Raspberry Pi Camera Module 2

PCN 62 – Change of sensor to Sony
IMX355

Product Change Notification

Change of sensor to Sony IMX355

Table 1.
Comparison Images

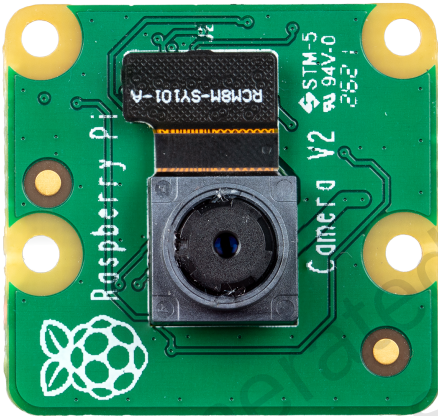
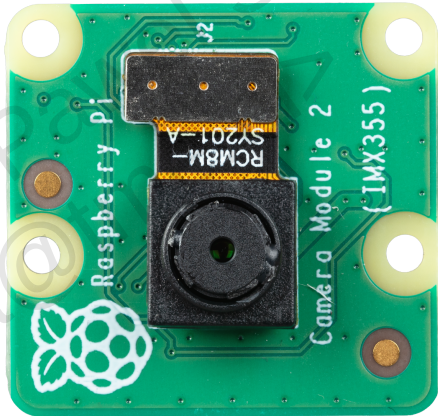
The new product can be distinguished by visual examination or by software.

Visual
